Calvert Cliffs Nuclear Power Plant, Unit Nos. 1 and 2  
Renewed Facility Operating License Nos. DPR-53 and DPR-69  
NRC Docket Nos. 50-317 and 50-318

**Subject:** Request for Additional Information Regarding the National Fire Protection Association Standard 805 License Amendment Request

**REQUEST FOR ADDITIONAL INFORMATION REGARDING THE  
NATIONAL FIRE PROTECTION ASSOCIATION STANDARD 805**

Figure 4-8 – NFPA 805 Monitoring Program Flowchart (Part 1 of 2)

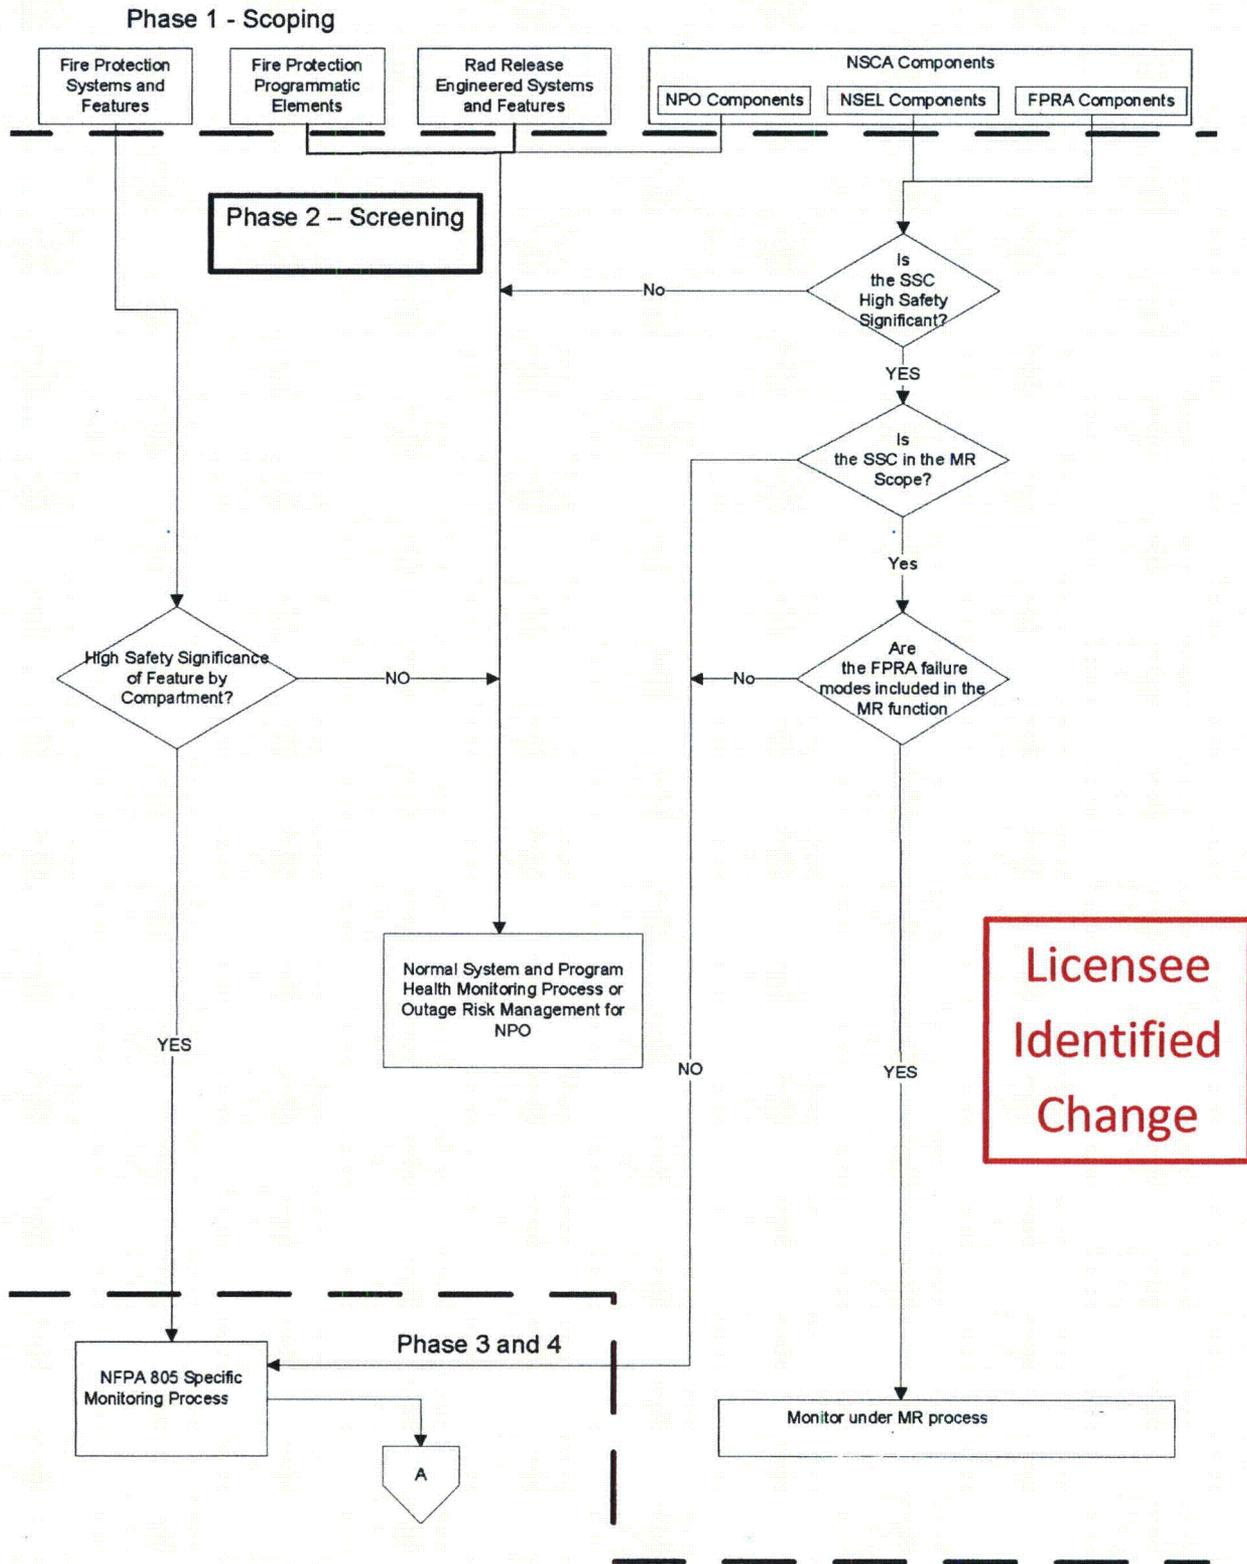
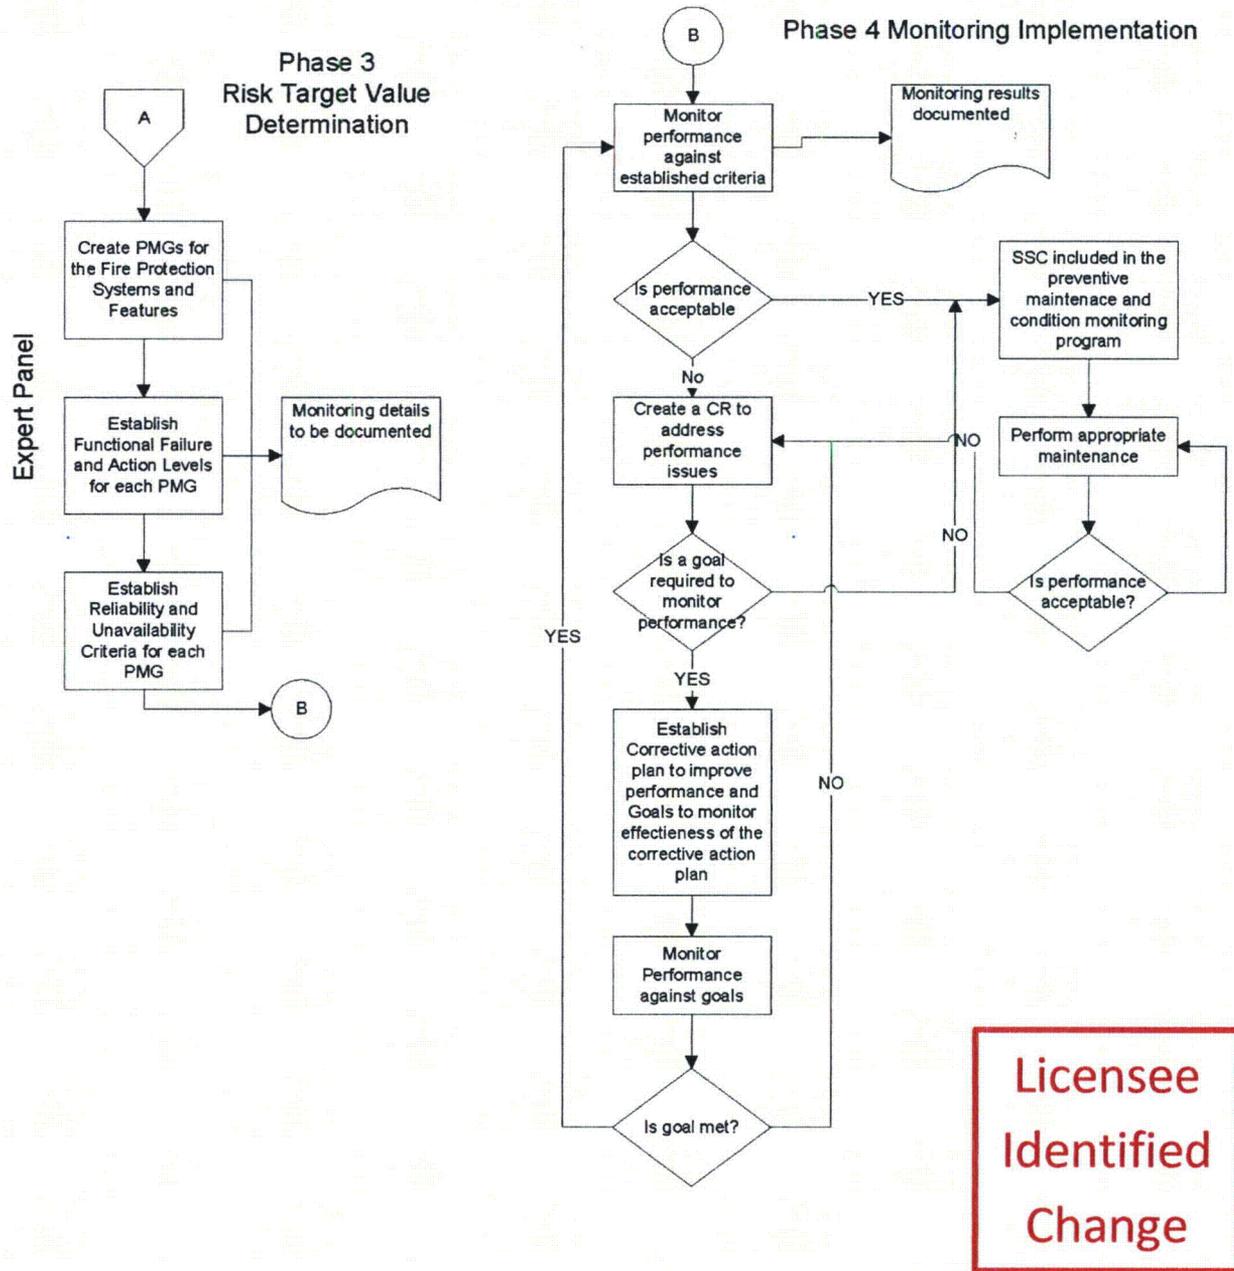
Another licensee identified change is described in updated pages 46 and 47. These changes update the flowchart. We request that these changes be included in the application review.

License Identified Change
